## Report to the Future Melbourne Committee

**Planning Permit Application: TP-2021-141**  
**695 Spencer Street, West Melbourne**

**30 November 2021**

## DELEGATE REPORT

Figure 10: Extract of demolition plan (source: Chahid Kairouz Architects Pty Ltd)

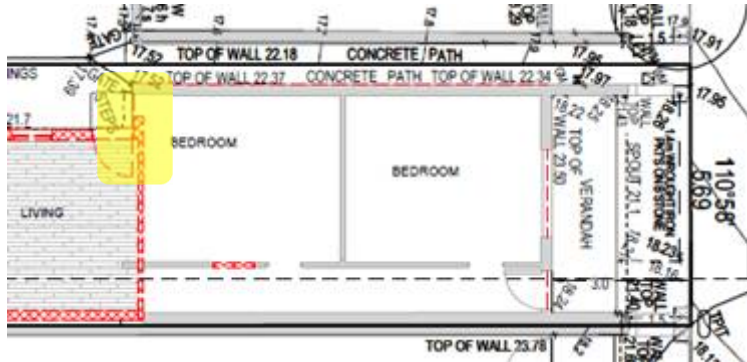
The Heritage Advisor provided the following recommendations:

- At the south elevation of the retained front wing, retain the double hung window and surrounding wall.
- Adjust the form of the proposed Bedroom 2, to include the retained elements.

**Figure 13: Site Coverage (Source: Chahid Kairouz Architects Pty Ltd)**

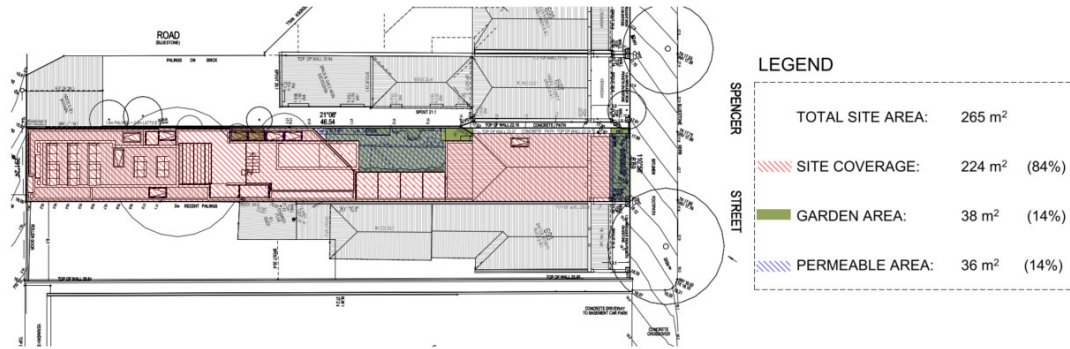
Variation is sought from Standard A5 (Site Coverage) of Clause 54. The existing site coverage is 58 per cent. A proposed site coverage of 84 per cent is proposed in lieu of 60 per cent (see Figure 14).

Variation from the standard is considered to meet the objective of 'To ensure that the site coverage respects the existing or preferred neighbourhood character and responds to the features of the site.' as:

**Figure 15: Second Floor Plan with recommended setbacks (Source: Chahid Kairouz Architects Pty Ltd)**

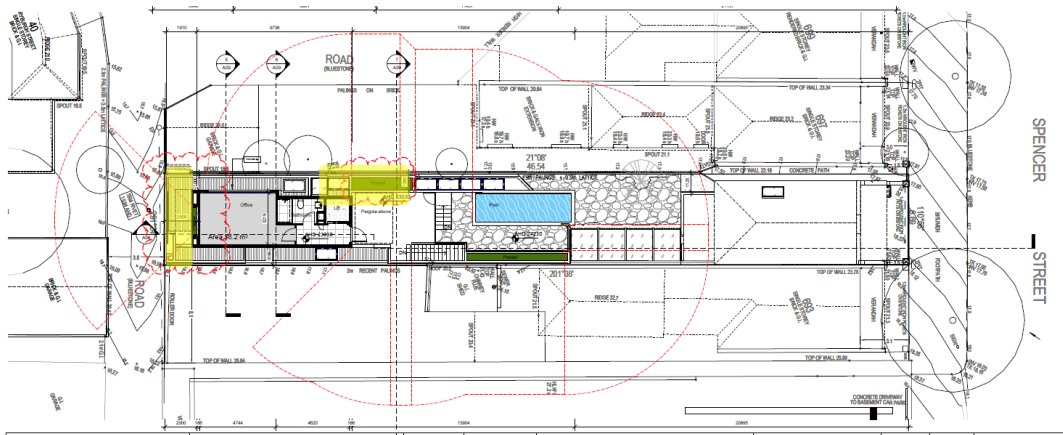
Variation from the standard is considered to meet the objective of *'to ensure that the height and setback of a building from a boundary respects the existing or preferred neighbourhood character and limits the impact on the amenity of existing dwellings'* because:

- The narrow lot width of 5.69 metres makes achieving the standard impractical.
- The addition cuts away from habitable room windows to the west.
- The proposal allows for development opportunities of the adjoining lots.
- The second floor is setback from the side and rear to reduce the visual bulk of the addition.
- A condition on the permit is recommended to increase the rear setback of the second floor by 2 metres and for the roof terrace to be setback 1 metre from the western boundary. See Figures 15 to 17.

- d. Inclusion of at least one deep planting zone showing the potential to accommodate at least one canopy tree.
  - e. The second floor setback a minimum of 2 metres from the rear boundary.

Figure 18: 22 September Shadow Diagrams (Source: C.Kairouz Architects)

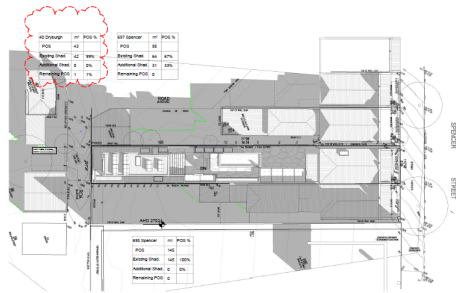
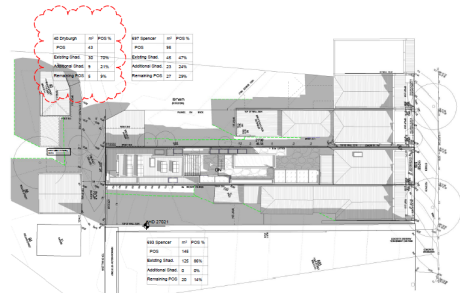
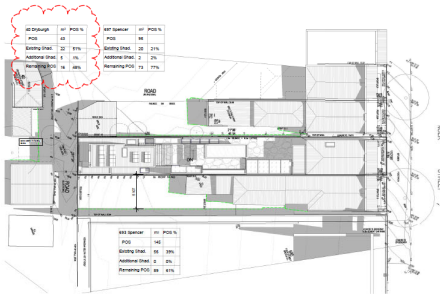
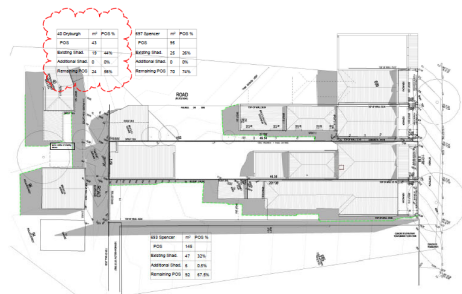
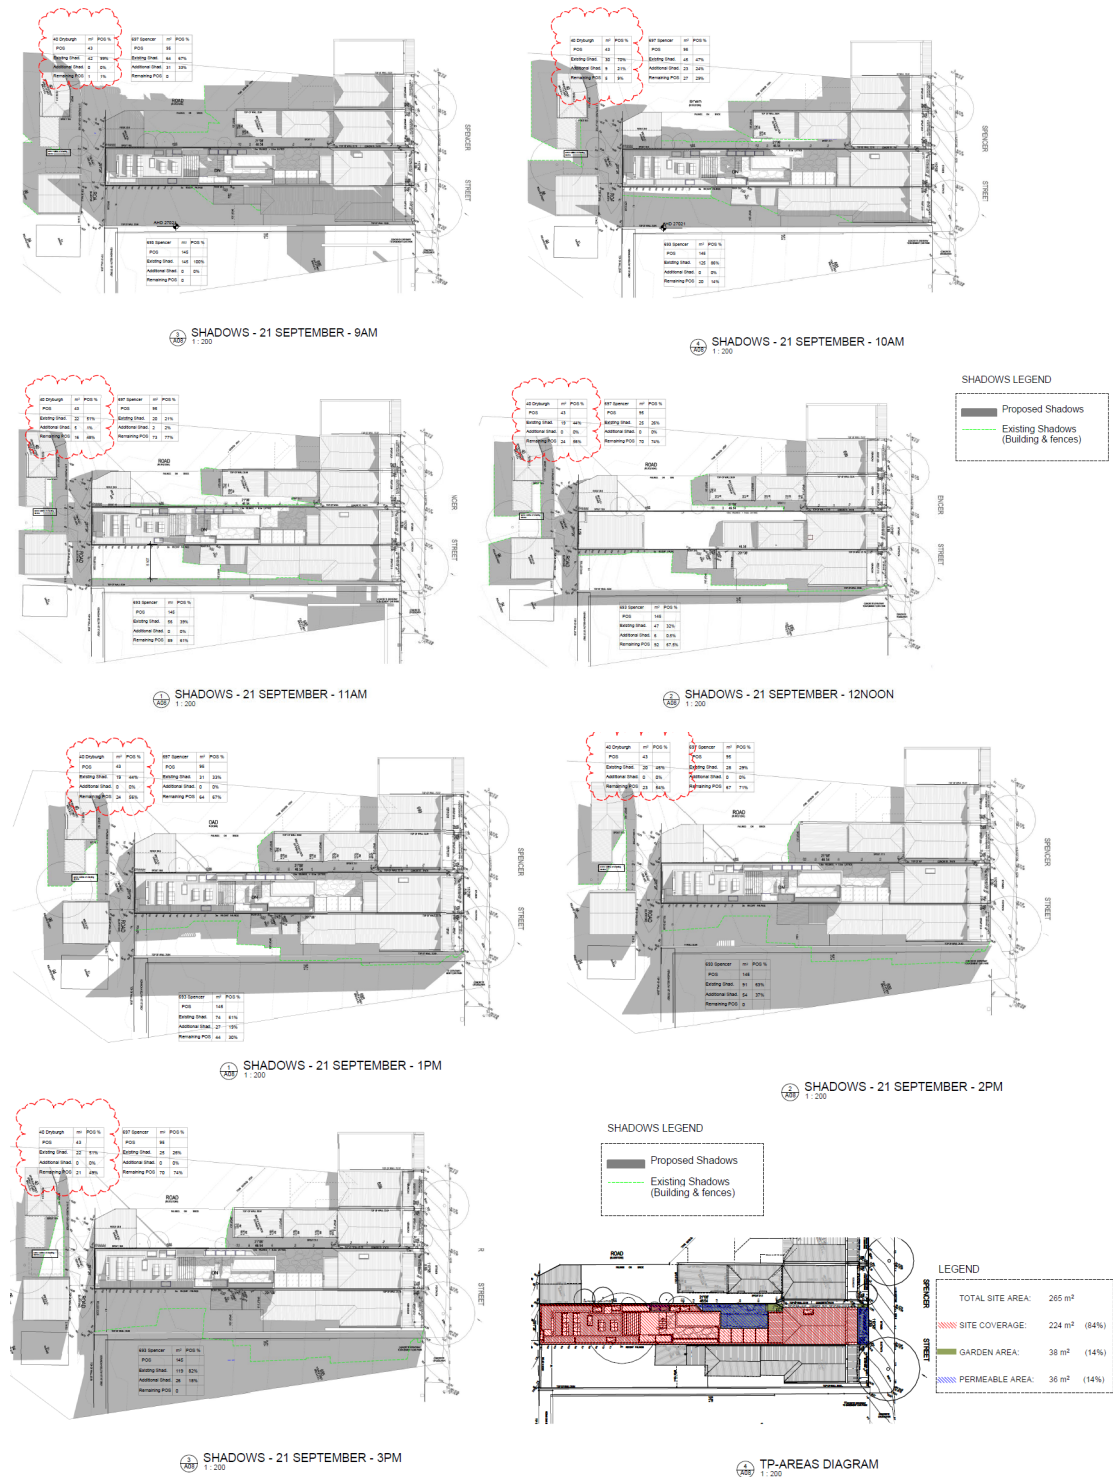
Variation is sought from Standard A14 (Overshadowing of Open Space). The following additional overshadowing is proposed to the existing secluded open space on the surrounding properties provided the recommended conditions increasing the second floor setback is imposed:

Table 4: Existing and Proposed Overshadowing			
Hour	697 Spencer Street 95 m <sup>2</sup>	693 Spencer Street 145 m <sup>2</sup>	40 Dryburgh Street 43 m <sup>2</sup>
9am	Existing: 64 m <sup>2</sup> 67% Additional: 31 m <sup>2</sup> 33%	No change	No change
10am	Existing: 45 m <sup>2</sup> 47% Additional: 23 m <sup>2</sup> 24%	No change	Existing: 30 m <sup>2</sup> 70% Additional: 9 m <sup>2</sup> 21%
11am	Existing: 20 m <sup>2</sup> 21% Additional: 2 m <sup>2</sup> 2%	No change	Existing: 22 m <sup>2</sup> 51% Additional: 5 m <sup>2</sup> 1%
Midday	No change	Existing: 47 m <sup>2</sup> 32% Additional: 6 m <sup>2</sup> 0.5%	No change
1pm	No change	Existing: 74 m <sup>2</sup> 51% Additional: 27 m <sup>2</sup> 19%	No change
2pm	No change	Existing: 91 m <sup>2</sup> 63% Additional: 54 m <sup>2</sup> 37%	No change
3pm	No change	Existing: 119 m <sup>2</sup> 82% Additional: 26 m <sup>2</sup> 18%	No change

The proposal is considered to meet the objective of ‘To ensure buildings do not unreasonably overshadow existing secluded private open space’ because:

Figure 19: Section Diagram showing recommended screening and setbacks (Source: C.Kairouz Architects)

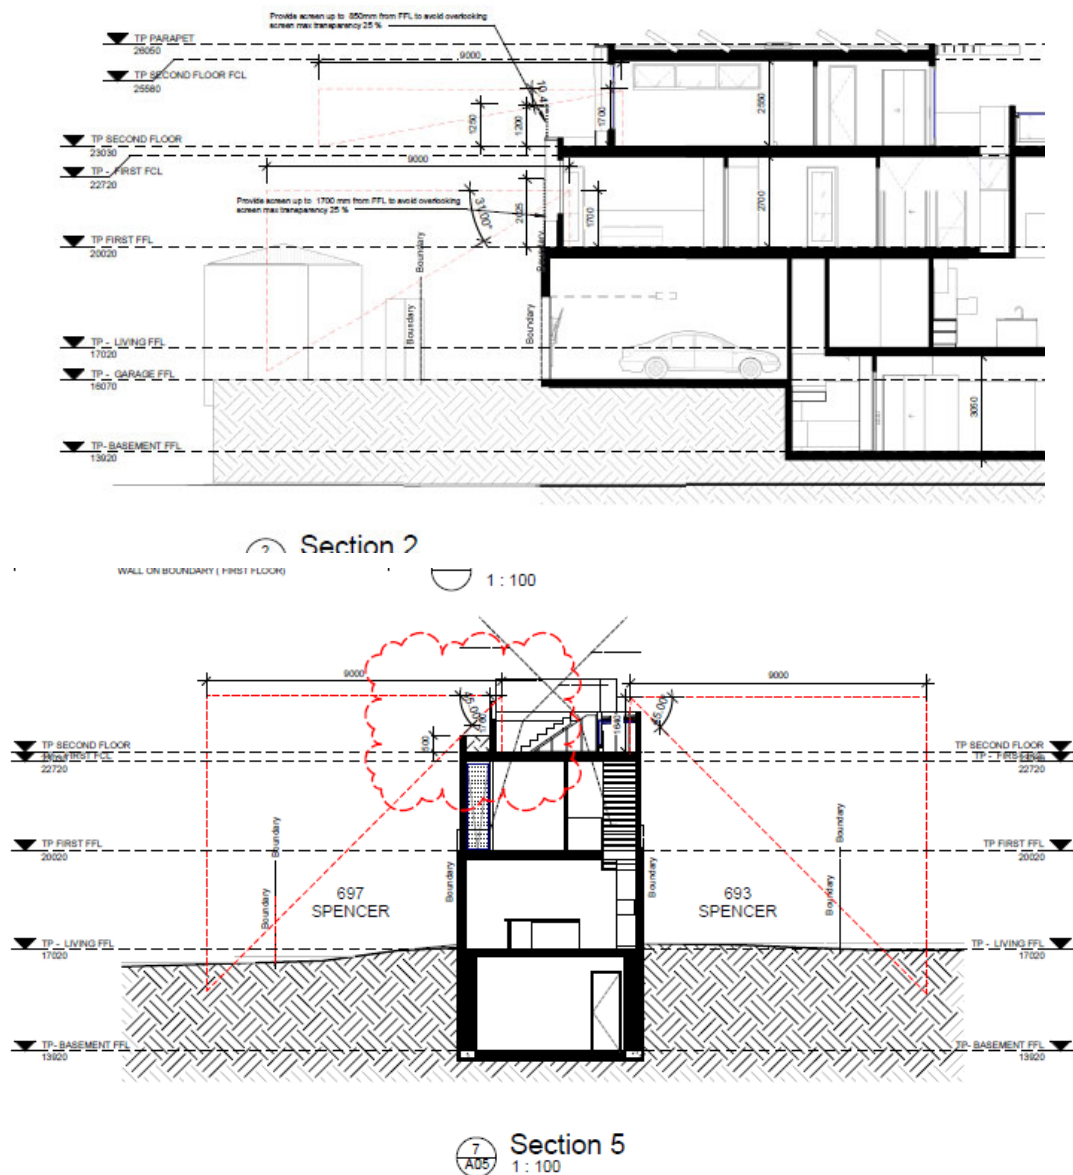
- The roof terrace being setback a minimum of 1 metre from the west boundary.
- Screening to the first-floor windows on the southern elevation extended to a minimum of 1.7 metres from the finish floor level.

Figure 20 First floor plan showing light courts highlighted with a recommended window to the return wall. (Source: C.Kairouz Architects)

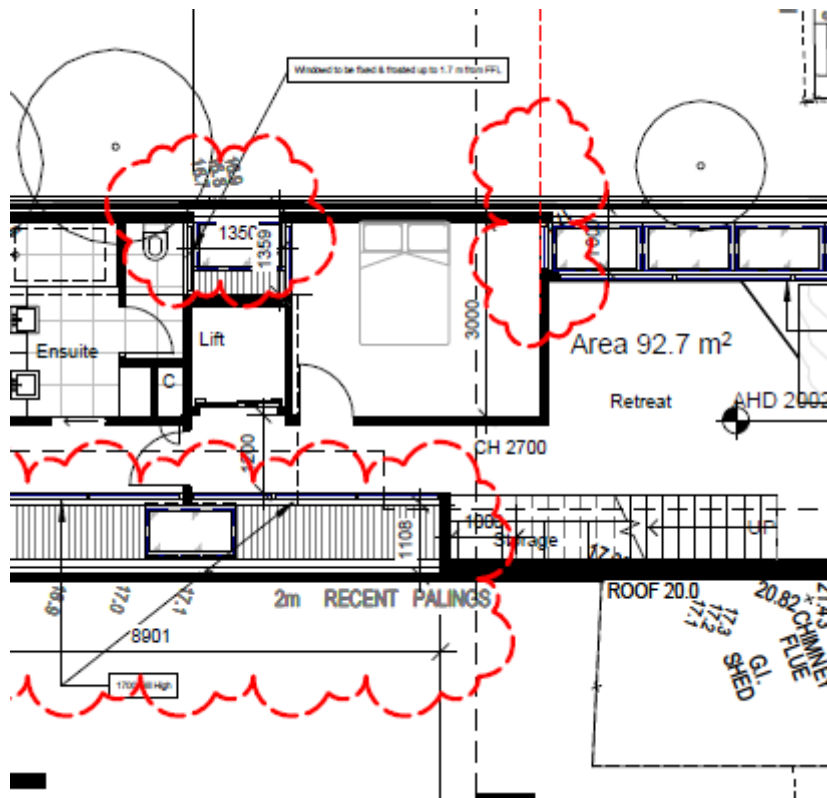
Variation is sought from Standard A16 (Daylight to new windows) of Clause 54 with a 1.35 metre by 1.36 metre (1.83 square metres) light court proposed on the first floor. This light court is proposed for a bedroom on the first floor. It is recommended that a condition should require a second window on the northern return wall to provide additional daylight access. Subject to the inclusion of this change, the proposal is considered to meet the objective of 'To allow adequate daylight into new habitable room windows'.

- h. A second window to the first floor bedroom on the northern return wall.
  - i. The colour elevations to show all external building materials.
  - j. Labelling on the elevation corrected.
